REGIONAL REVIEW NOTIFICATION

RE: Development of Regional Impact Review

Name of Proposal: Brand Properties Hamilton Mill DRI 3812

<u>Description</u>: A DRI review of a proposal to construct a mixed-use development with 700 multifamily units and 17,000 square feet of commercial space on a 79-acre site off Sardis Church Road in unincorporated Gwinnett County.

CS-101

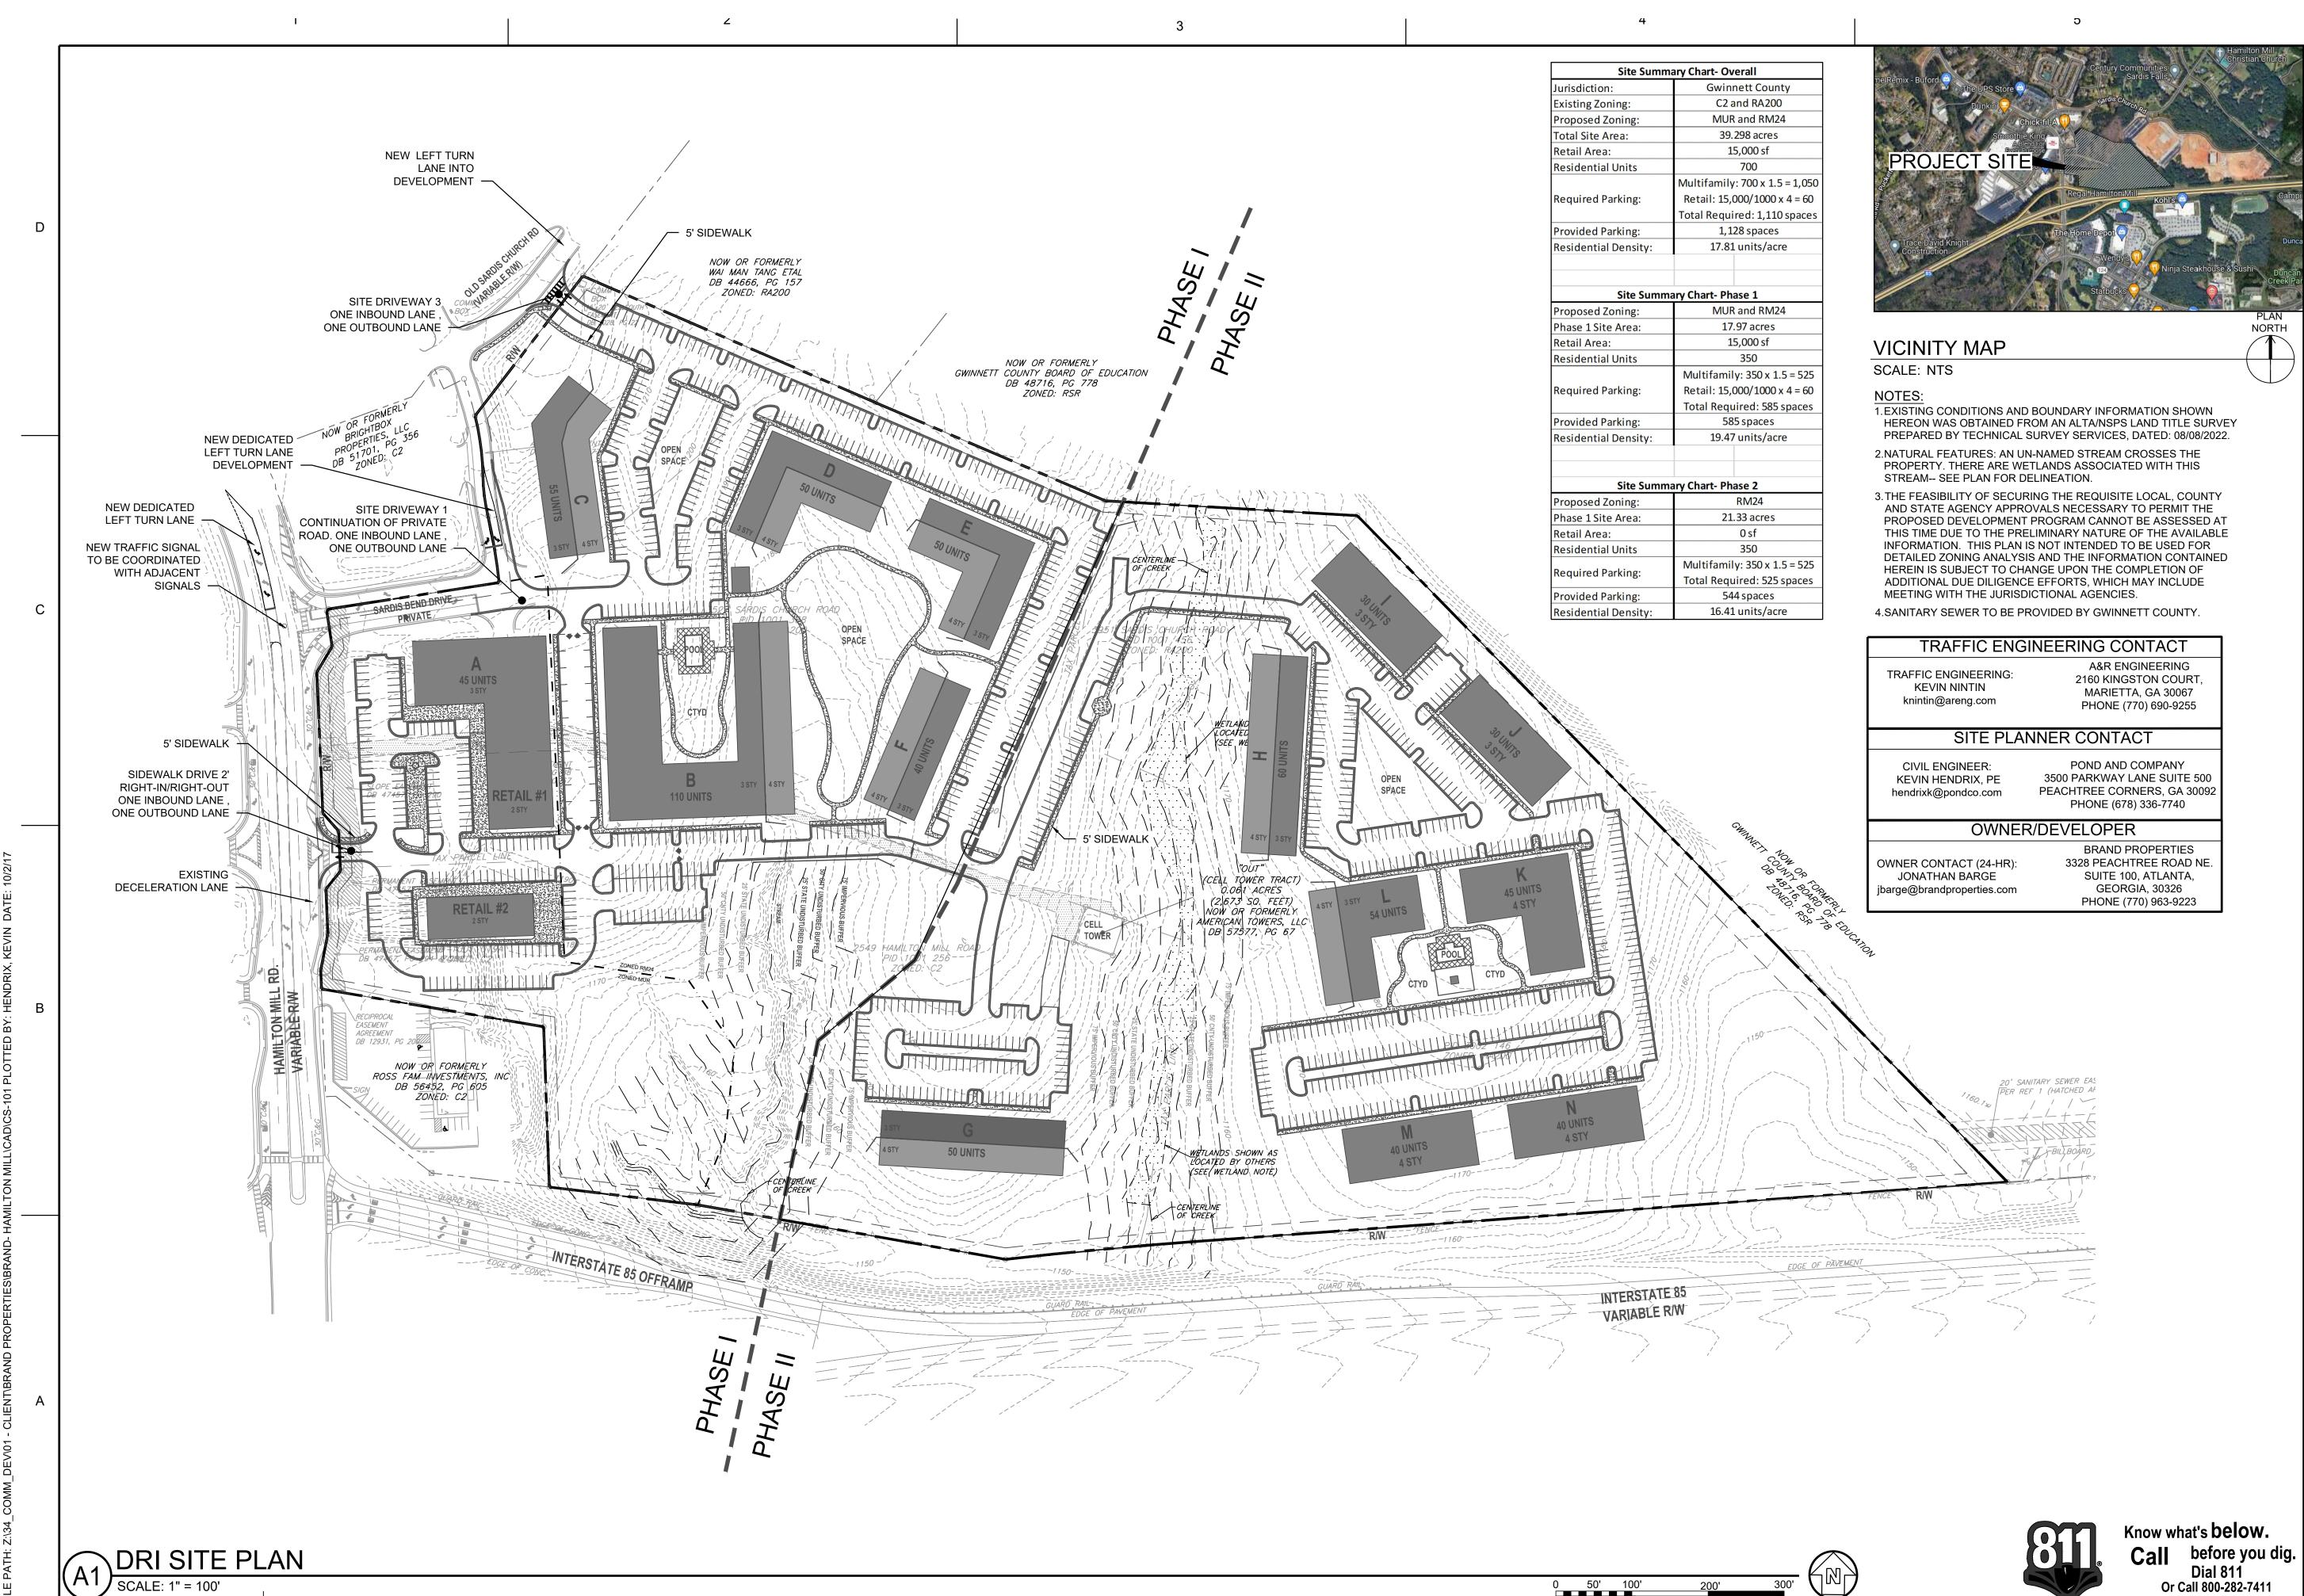
A total of 2,250 parking spaces are provided which is marginally more than the number required. Regional multi-modal transportation policies are supportive of reduced parking and a modest parking reduction may be warranted.

No EV charging spaces appear to be identified; provision of adequate EV charging spaces would be supportive of regional EV infrastructure policies.

Incorporation of green stormwater and heat island mitigation designs for the large number of surface car parking spaces proposed would be supportive of regional environmental policies.

Care should be taken to ensure that the constructed development provides an interconnected, functional, clearly marked and comfortable pedestrian experience on all driveways, paths, entrances, and parking areas. To the maximum extent possible, new driveways and intersection corners where pedestrians will cross should be constructed with minimal curb radii to reduce speeds of turning vehicles and decrease crossing distances for pedestrians.

A significant amount of forested stream and wetland buffer area is proposed to be retained. Additional retention of these areas would be desirable and in keeping with regional goals regarding carbon sequestration and climate change/heat island effect mitigation. Designation of this area as managed open/conservation space could meaningfully reduce the overall impact of the project.

The project can support The Atlanta Region's Plan in general by incorporating other aspects of regional policy, including green infrastructure and/or low-impact design, e.g., pervious pavers, rain gardens, vegetated swales, etc., in parking areas and site driveways, and as part of any improvements to site frontages.

Incorporation of green stormwater and heat island mitigation designs for the large number of surface car parking spaces proposed and use of an ecosystem-based design for the two stormwater detention areas would be supportive of regional environmental policies.
